New Albany Planning Commission Agenda
Wednesday, January 19, 2022 7:00pm

**Planning Commission Staff Report
January 19, 2022 Meeting**

LOCATION: Generally located north of Jug Street, east of Beech Road and west of Harrison Road in Licking County (portion of PID: 095-111756-00.000).
APPLICANT: LPC Midwest LLC
REQUEST: Preliminary and Final Plat
ZONING: Limited General Employment (L-GE)
STRATEGIC PLAN: Employment Center
APPLICATION: FPL-132-2021

Re: Horizon Court Plat

SHEET NAME:
RECORD PLAT

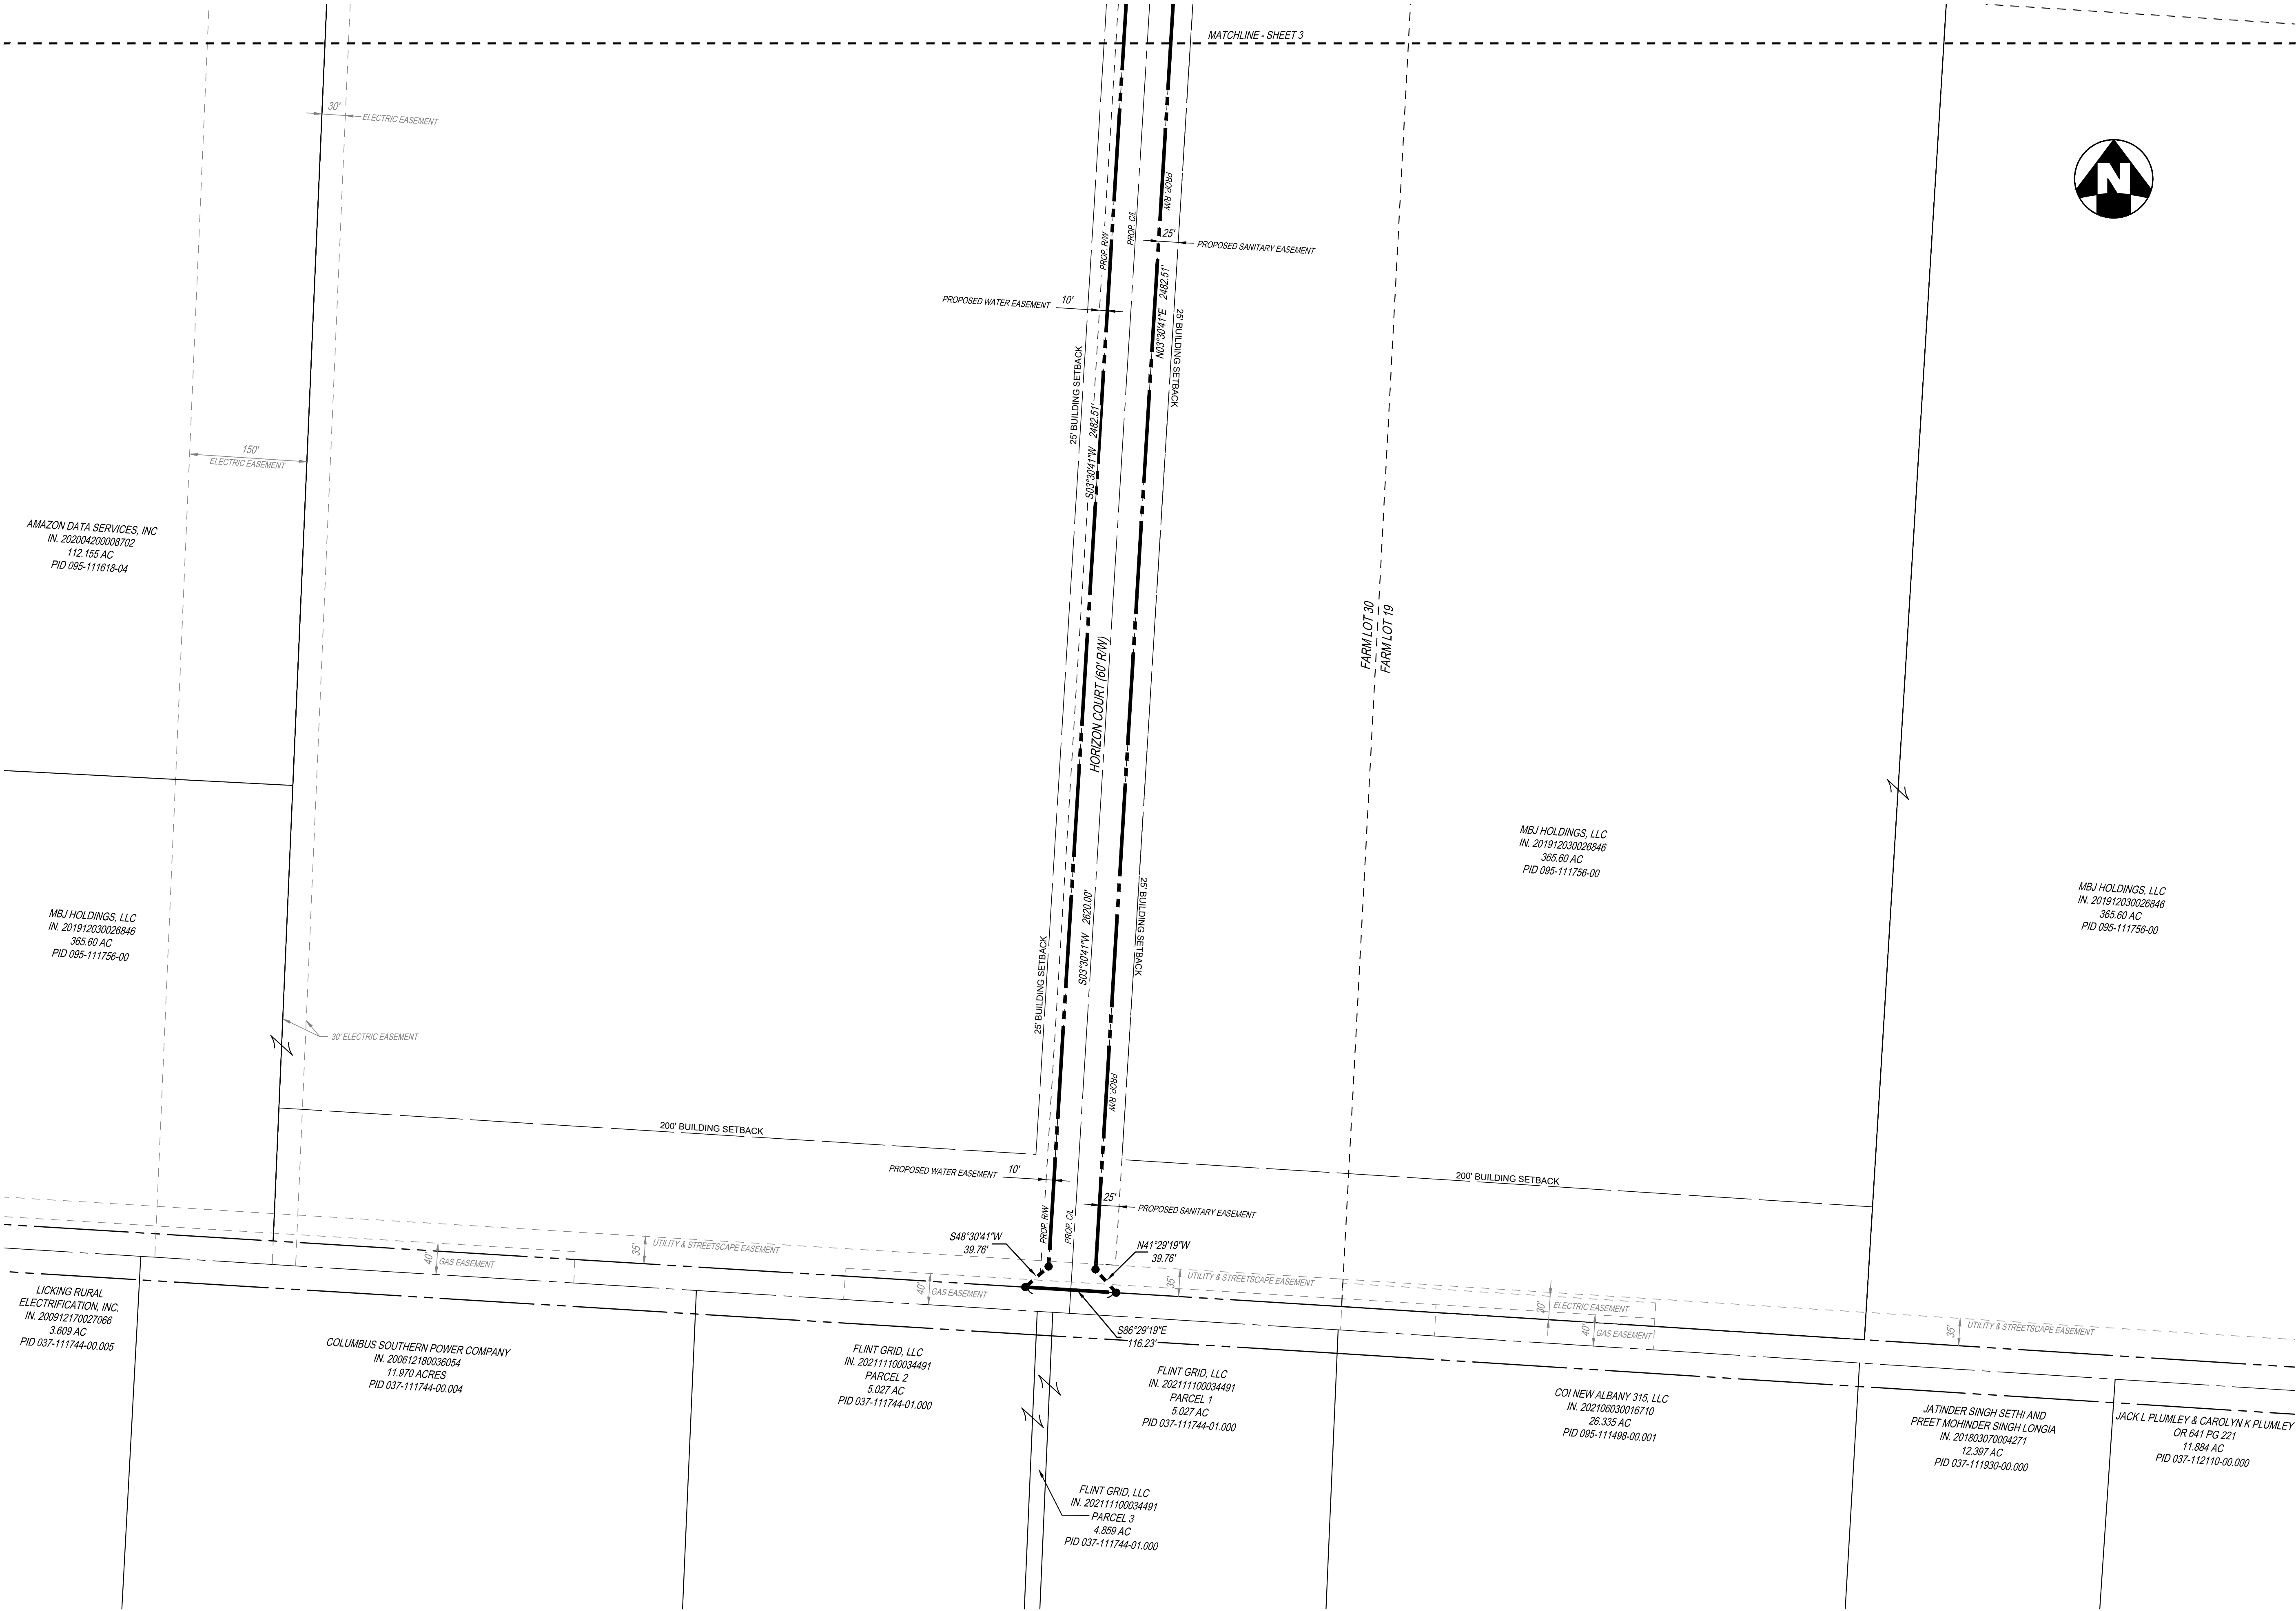
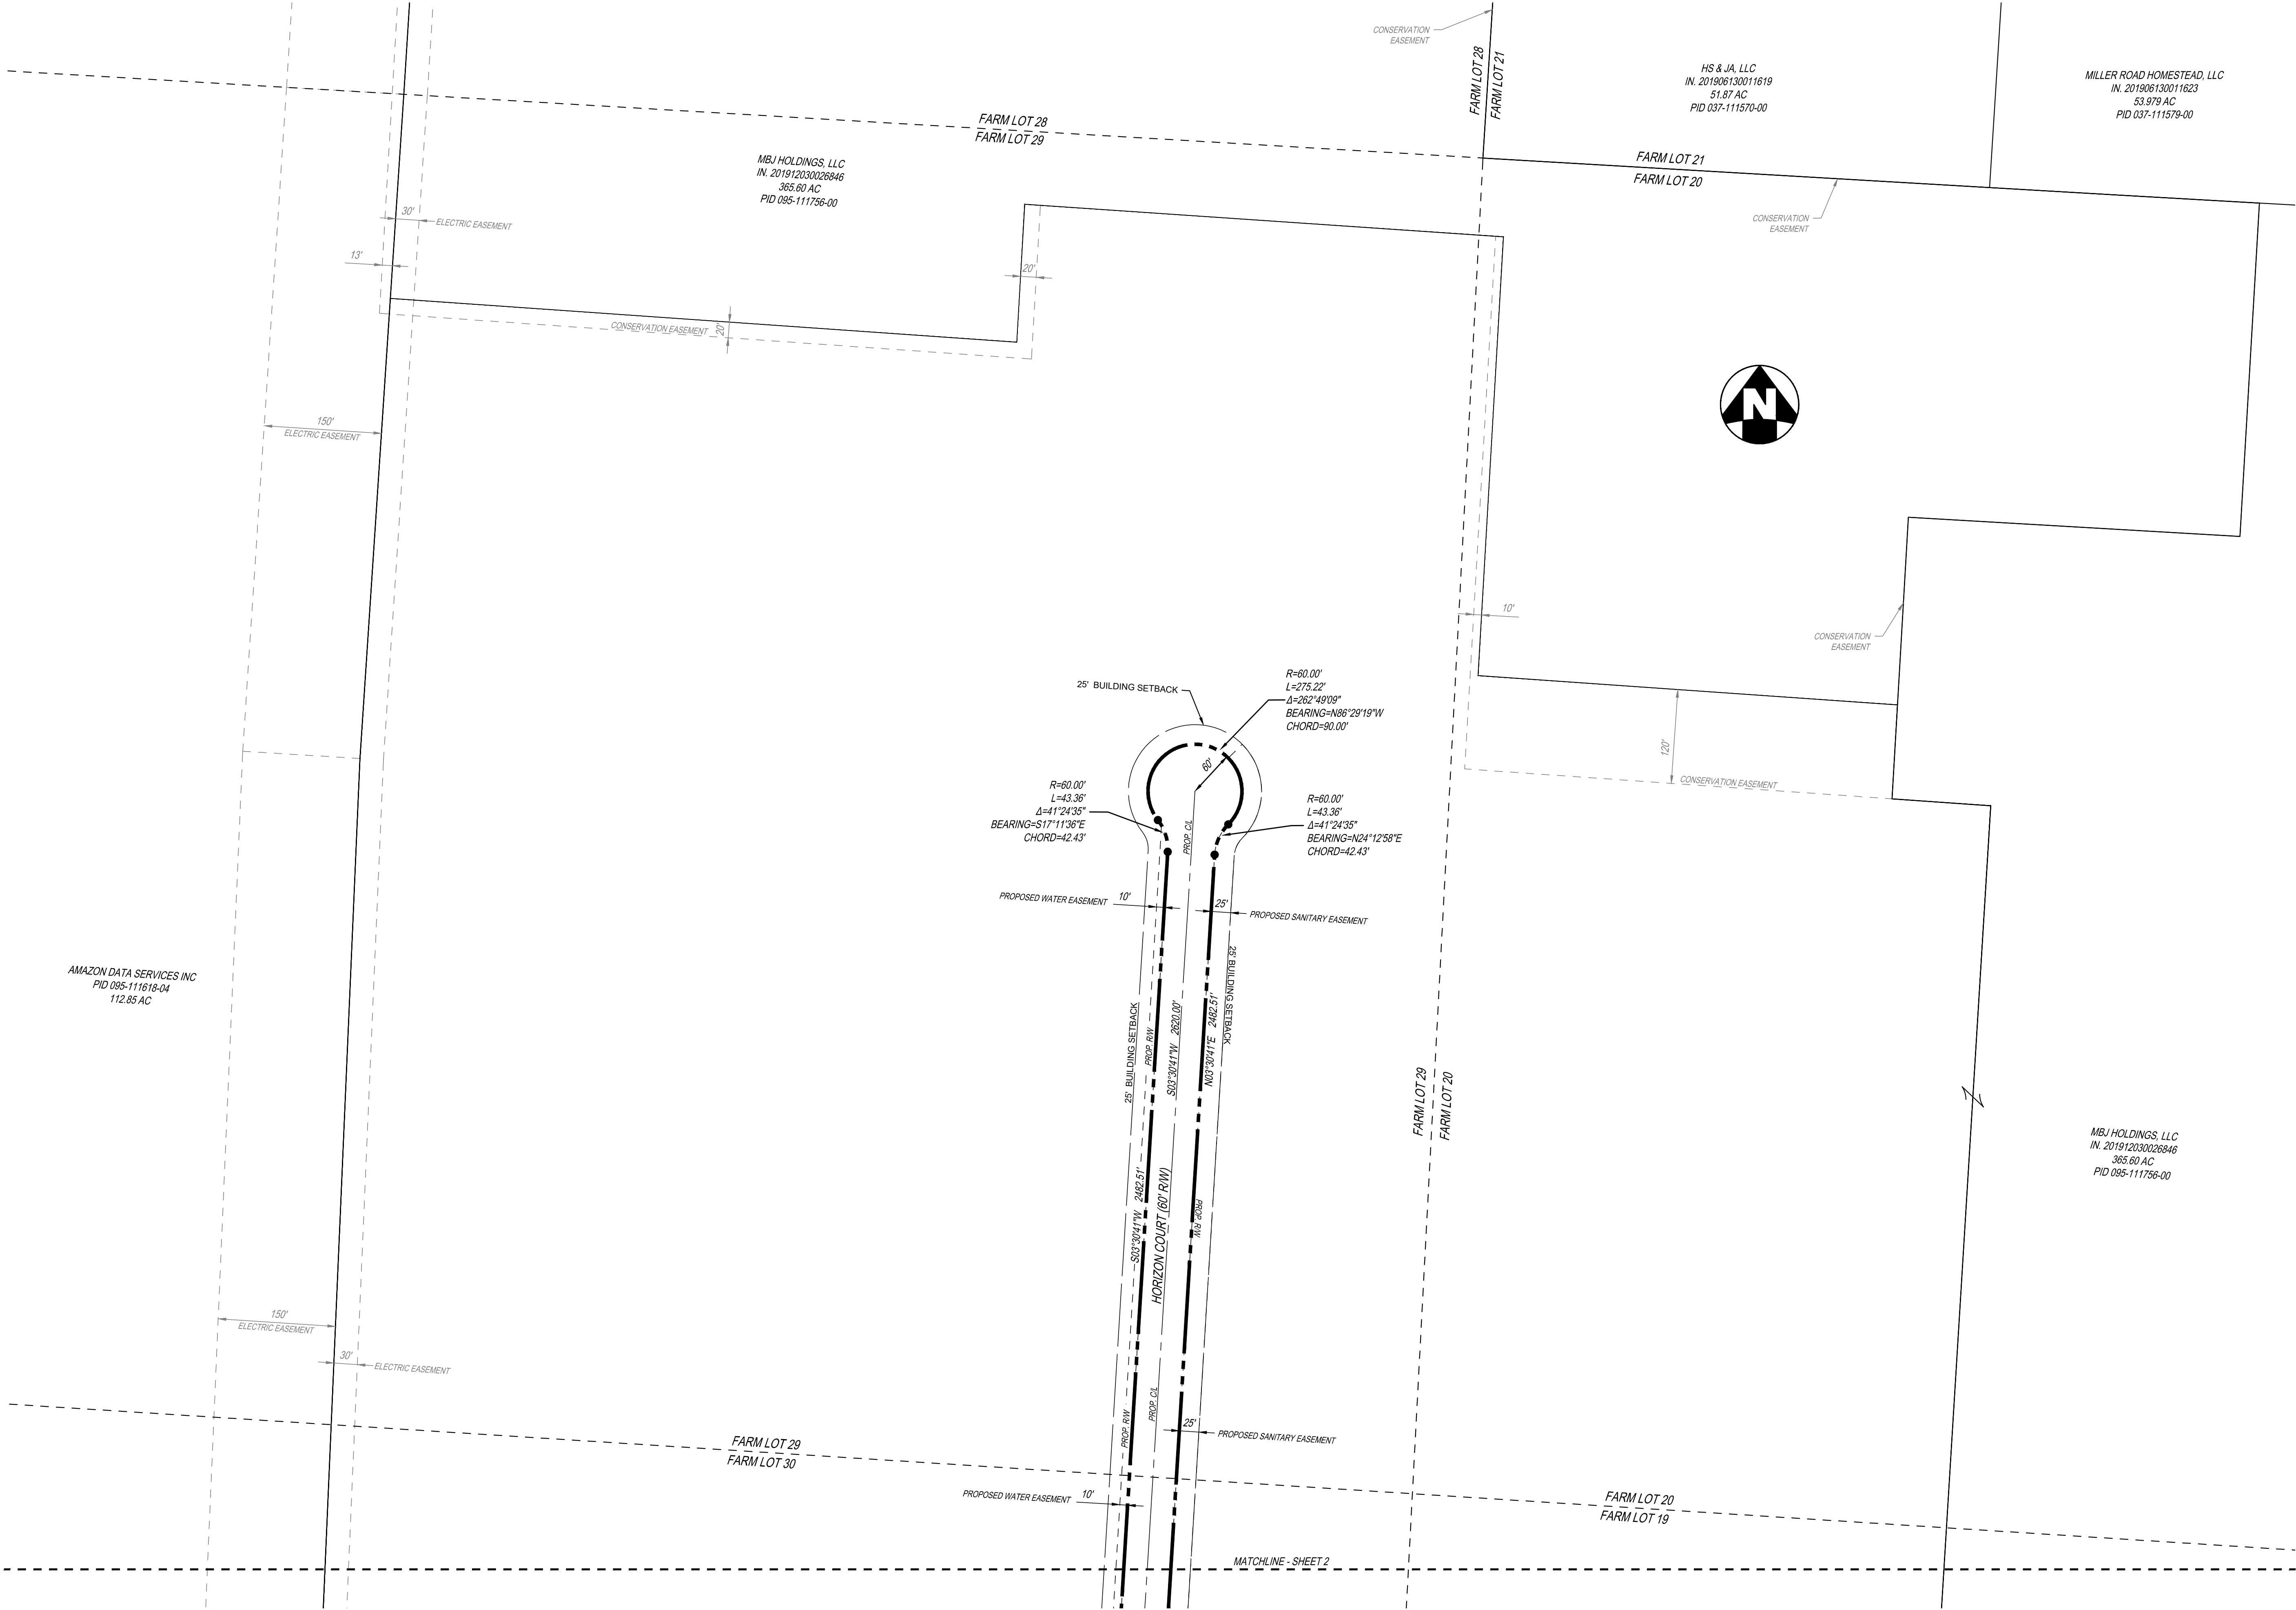
1. Provide more information on the plat regarding cross access easements that will accommodate emergency responders.
2. Obtain approval from the City of Columbus for the proposed 10' water line easement. Ensure that the easement is wide enough to maintain a minimum 7.5' offset from the water main and right-of-way and 20' offset from all building structures.

3. In accordance with code section 1187.06 (a)(2) show the angle and distance to the nearest street intersection.
4. Provide more information on the plat regarding the provision of utility easements to accommodate private utility providers (e.g., gas, telecom, electric, etc.).

5. In accordance with code sections 1187.06 (c)(1) and (2), provide written documentation indicating that Ohio EPA and Army Corps of Engineers permitting issues have been addressed.

6. Refer to Exhibit A. Reformat the plat in accordance with this exhibit including adding Horizon Court to the title block.
7. Show drainage easements on the plat associated with the regional basin. Provide the City's standard drainage easement note block on sheet 1 of the plat.

Site Plan

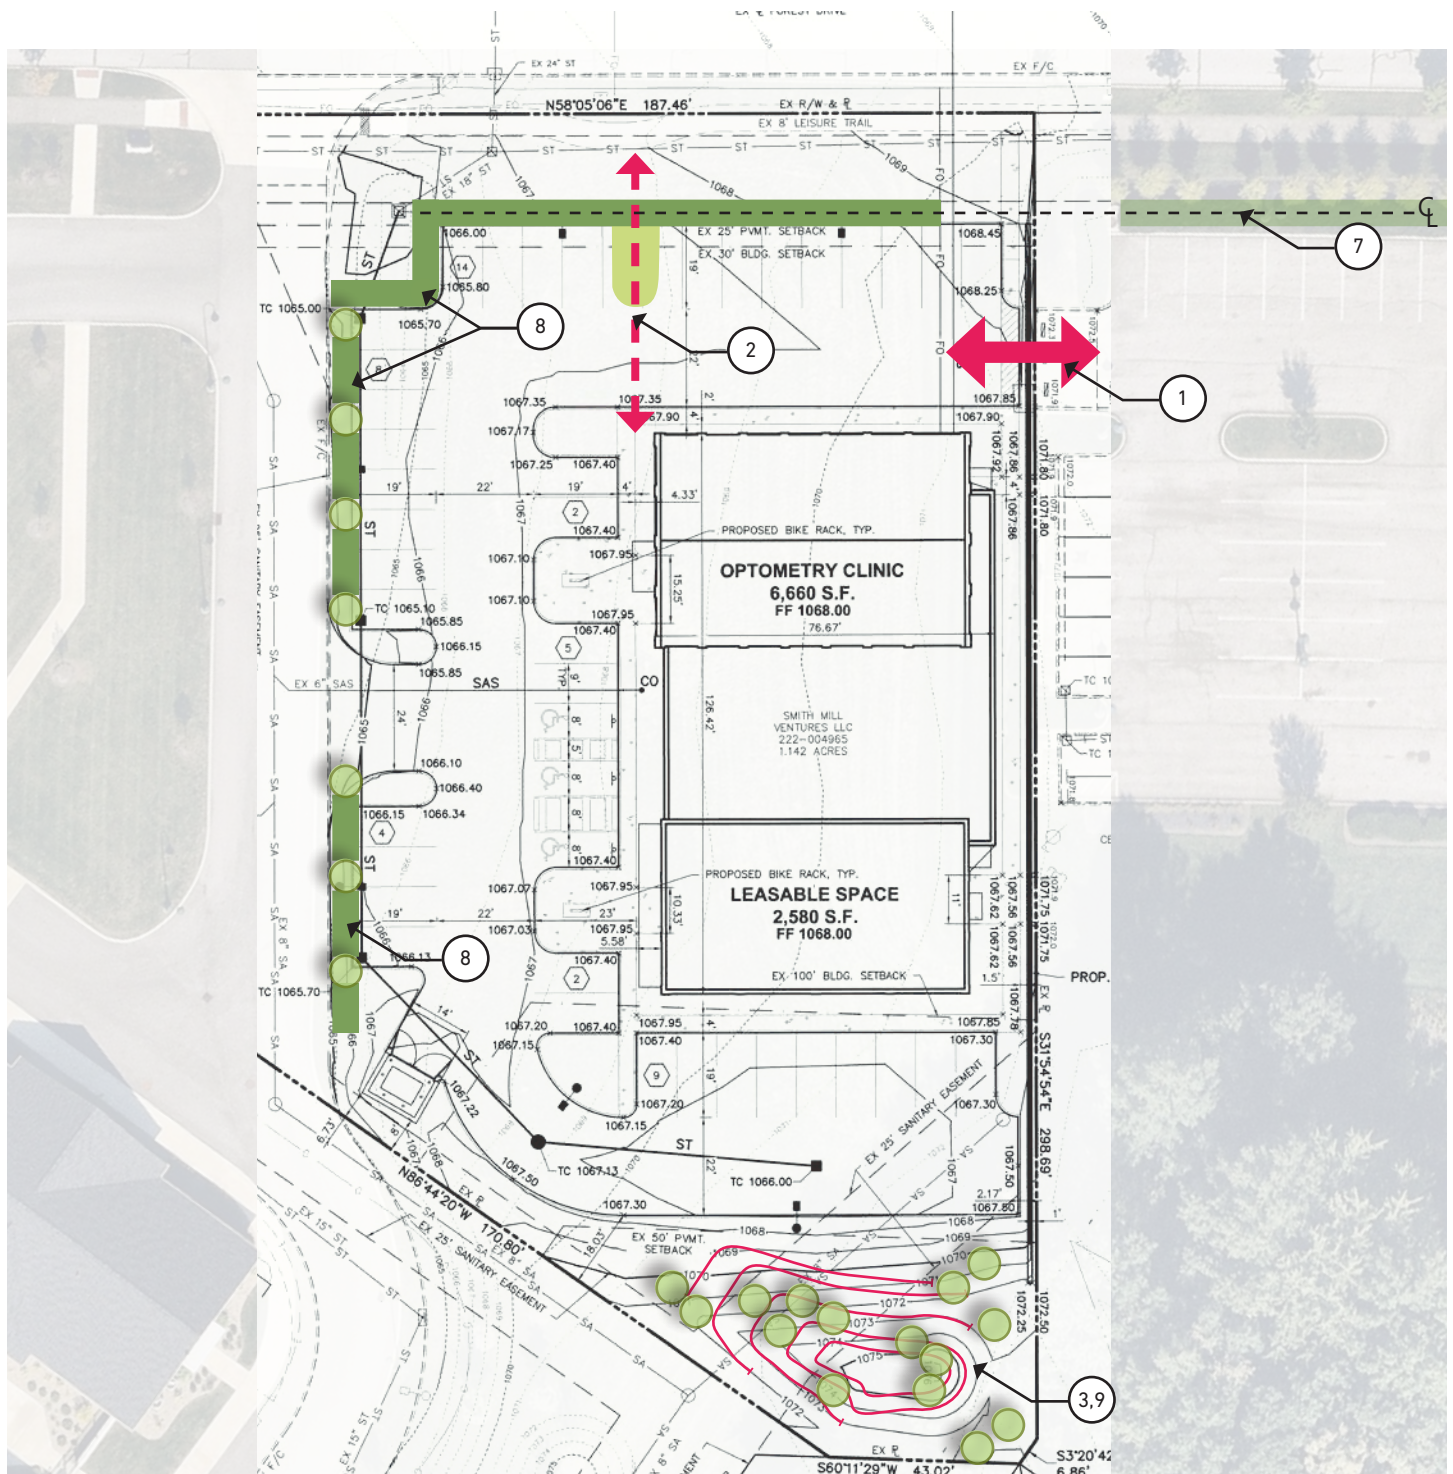
1. Connect proposed drive to existing Park & Ride stub out. Adjust retaining wall as needed. See diagram.
2. Provide a better pedestrian connection across the site from the leisure trail and align the walkway with the paving around/at the entrance of the building. Adjust parking and islands as needed. See diagram.
3. Regrade the screening mound at the southwest corner of the site to provide better screening and appear more natural.
4. Please provide all dumpster enclosure details to the city of New Albany for review.
